Design Review Committee for SPI-9  
SAP Application - Updated Project Summary Letter

Project: 99 West Paces (Restaurant)  
Address: 99 West Paces Ferry Rd NW Atlanta, GA 30305  
Project Area: 3,576 SF Interior Conditioned Area (+744 SF Kitchen Mezzanine)  
Building Height: 12 Story High Rise, Tenant Space Height is ~18'-0"

ENLARGED PROPOSED  
EXTERIOR ELEVATION  
RENDER

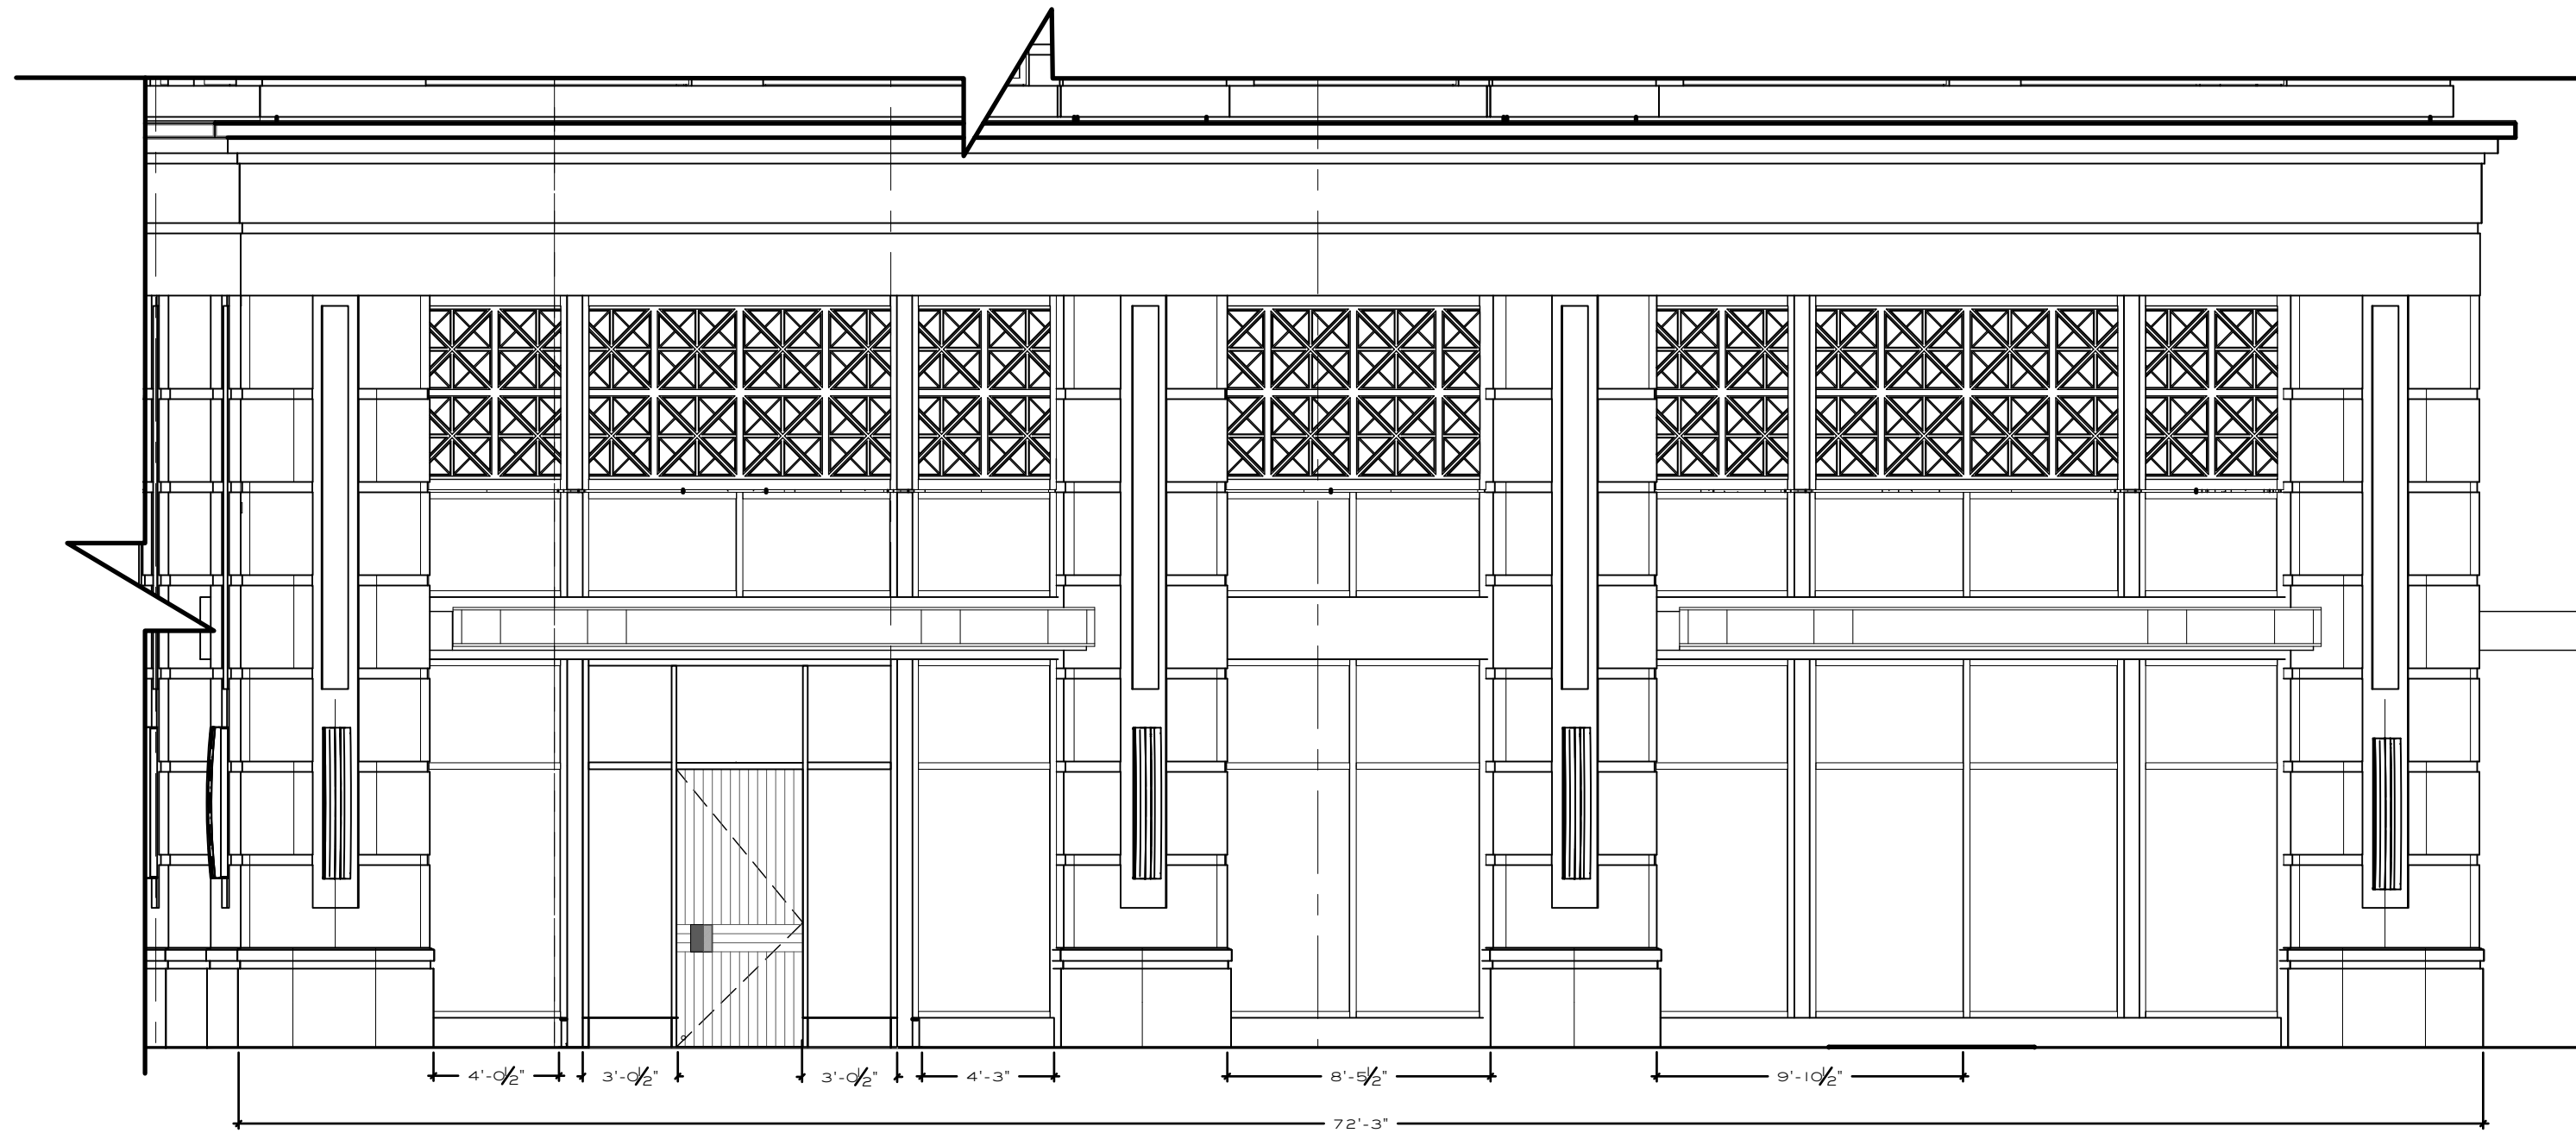
**Recommendation:** One of the major goals of the Special Public Improvement District regulation is to create a walkable community. Fenestration requirements are a key tactic to achieve this as they are intended to create an engaging pedestrian experience along the adjacent sidewalk by allowing passersby to see into the establishment. While the committee understands, the applicant desires to achieve an intimate feeling inside the space, the proposed approach, literally blocking out the windows, would set an undesirable precedent counter to the goals of the district. Therefore, the committee recommended the applicant revise their design, particularly as it relates to the treatment of the windows along West Paces Ferry that are not proposed to receive the stone and wood entrance treatment.

1. Reconfigure the layout of the restaurant to allow for the remaining windows along West Paces to be converted into (retail) display windows that are internally illuminated and provide visual interest to pedestrians.
2. Establish an artistic, visually attractive installation on the street facing side of the proposed partition walls to provide an engaging pedestrian experience on the exterior of the space,
3. Retain the windows proposed to be converted to opaque glass and walled over in some manner to allow for pedestrians to look into the restaurant before 5p.

Our revision to the design proposes to keep the existing storefront and visibility into the space from the sidewalk for the entirety of the West Paces Ferry storefront frontage aside from the 4 linear feet of new opaque entry door and the equipment that is being visibly blocked at the far right portion. We have removed the interior partitions and will plan for views in and out. The portion of windows at the far right / East side of our space along West Paces Ferry will have some custom wine storage and cooling equipment that will not allow for any views to the interior of the space. Our design intent is to keep those windows in the design as opaque.

FENESTRATION  
 CALCULATIONS

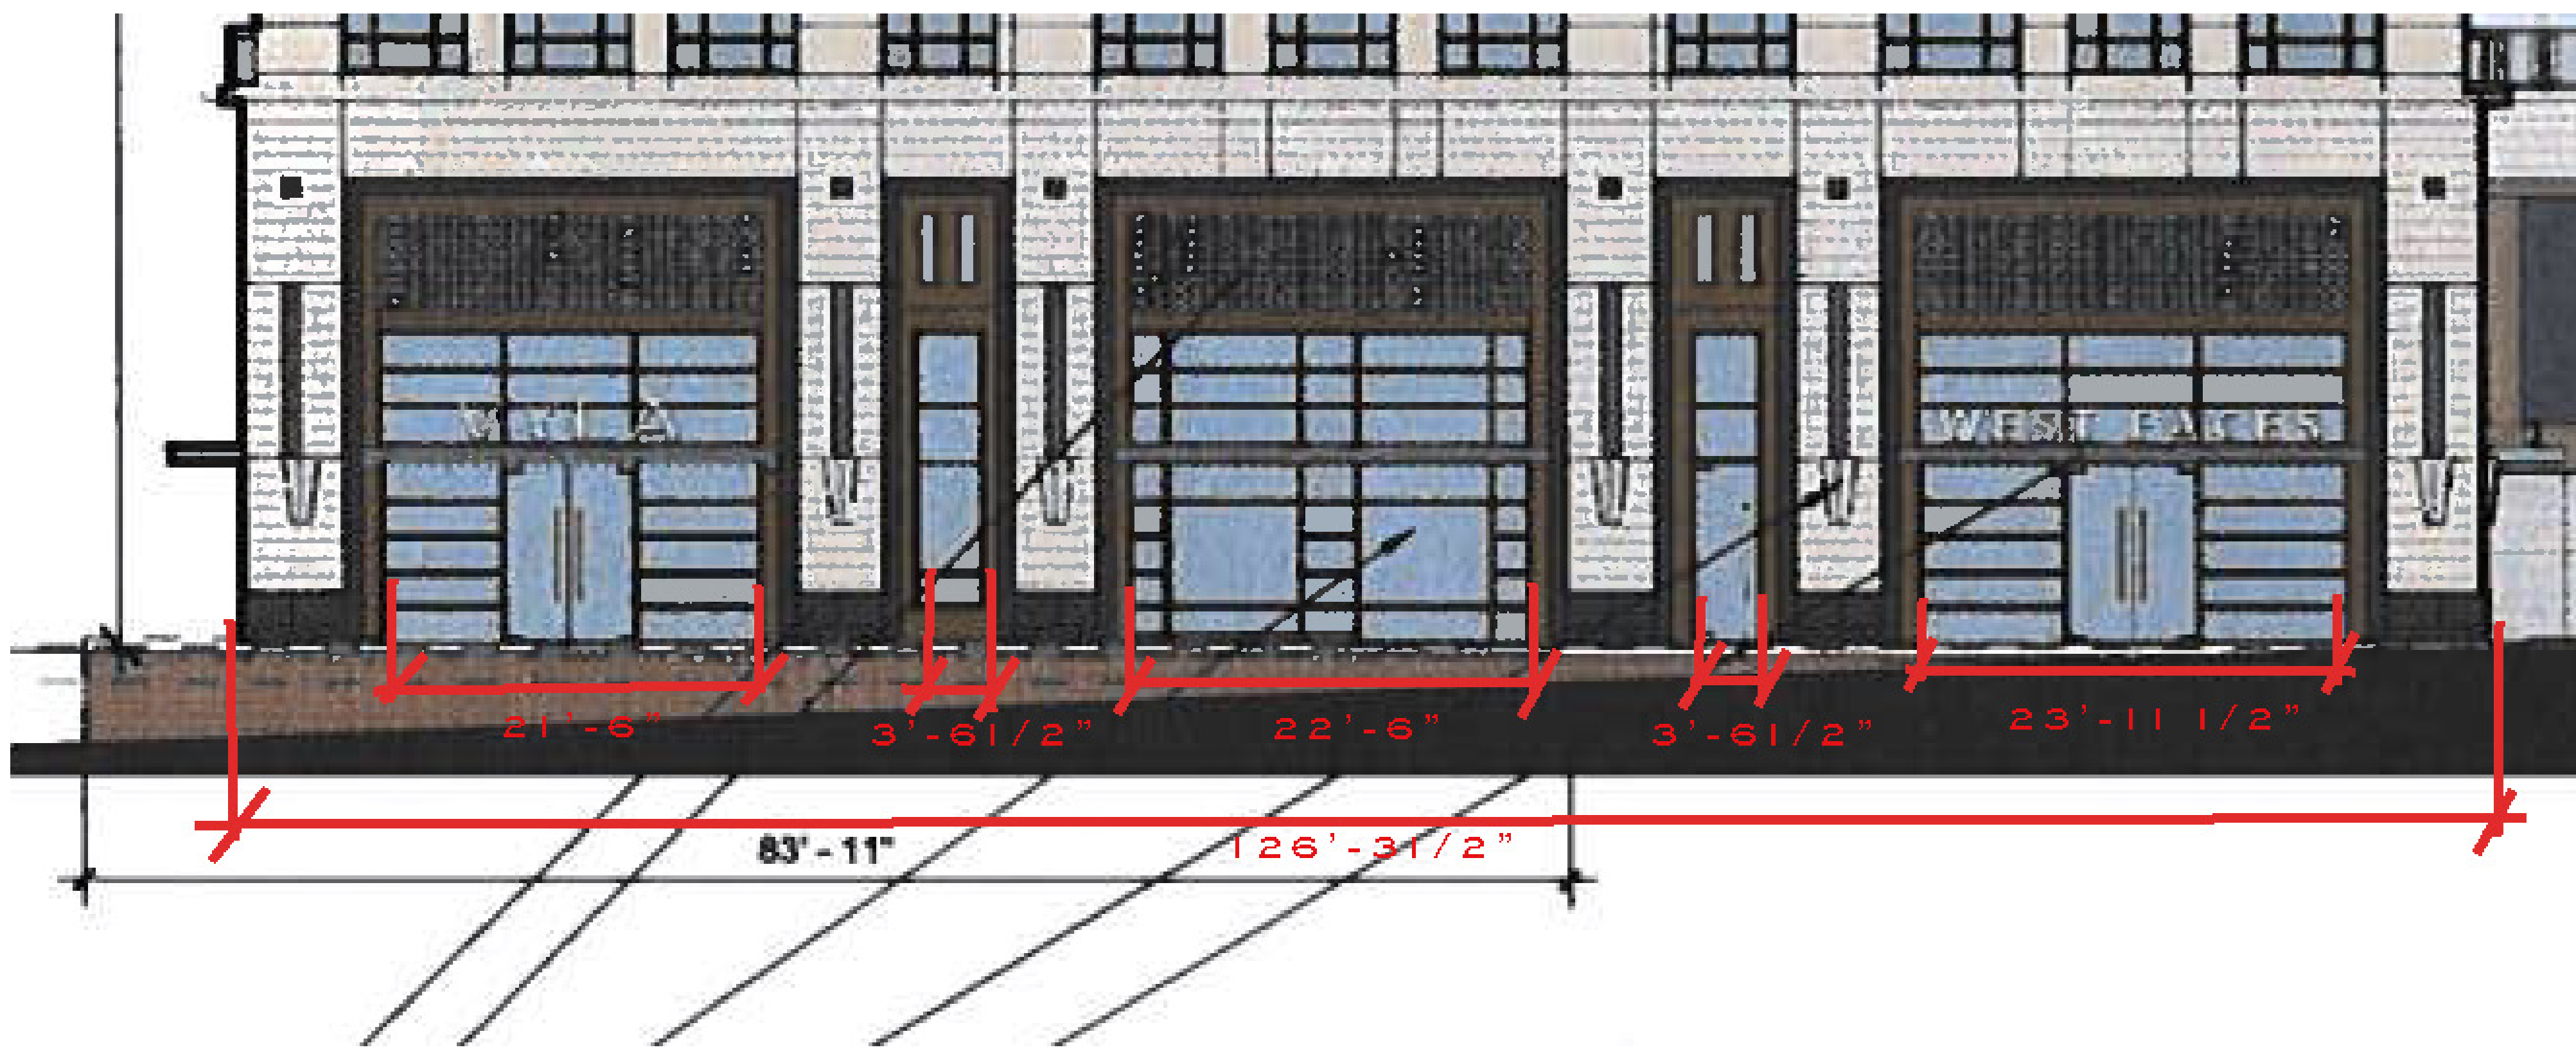
We are Requesting a Variation from the Atlanta zoning code 16-18I.017-5 fenestration requirement of 65%. We are altering a section of storefront / fenestration to become opaque at the entry door, which calculates to a decrease in fenestration from 65.3% down to 54.2% for the length of the street frontage along West Paces Ferry at ground level.

*Sec. 16-18I.017.5: Fenestration including all window and door openings shall be provided at the sidewalk level for a minimum of 65 percent of the length of the building for nonresidential uses.* The code requires 65% fenestration along West Paces Ferry Road and the approved SAP 18-131 which allowed for construction of the full building met this requirement at 65.3%. While this SAP will only modify a portion of the full street frontage, fenestration in the affected area will drop to zero and significantly reduce the overall fenestration to well below code requirements.

For Resubmission and Response to the DRC Recommendations above, we are submitting revised design drawings. The change to the design aligns with the DRC Recommendation #3.

198' - 6 1/2" TOTAL FACADE LENGTH  
 93' - 4 1/2" TOTAL FENESTRATION LENGTH  
 REQ'D FENESTRATION = MIN 65%  
 PROVIDED FENESTRATION = 107' - 8 1/2" / 198' - 6 1/2" = 54.2%
